**PRIOR RECLAMATION INSPECTION REPORT
AND
RECOMMENDATION FOR RELEASE OR PERMIT
REQUIREMENT**

United Nuclear Corporation - Anna Lee Mine

**New Mexico Energy, Minerals and Natural Resources Department
Mining and Minerals Division
Mining Act Reclamation Bureau**

August 3, 1995

Photos 3&4. Top of site with concrete cap from southeast

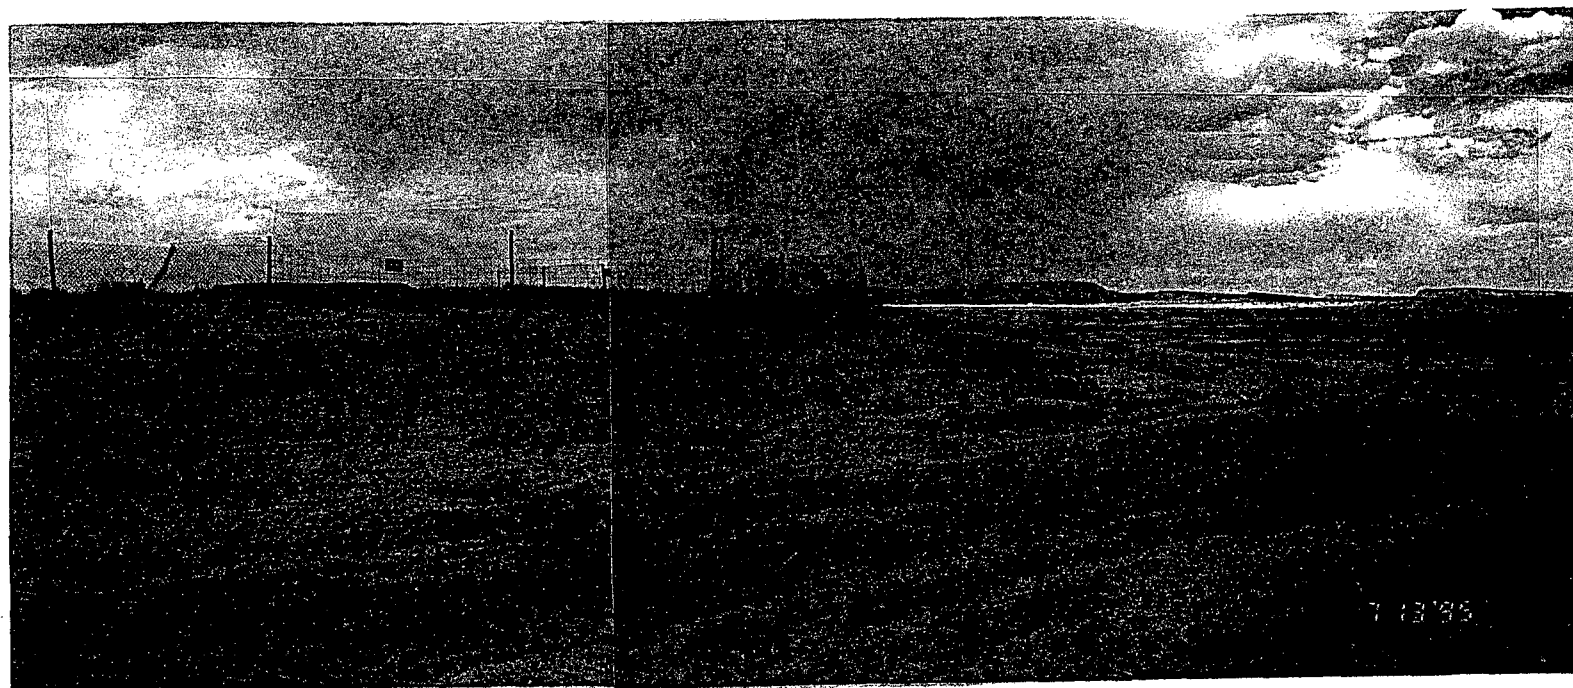
1. The concrete slab must be covered by a minimum of one foot of top soil or suitable material.
2. The area must be reseeded with a mixture of native species appropriate for the area. MMD staff will be happy to advise United Nuclear regarding an appropriate seed mixture.
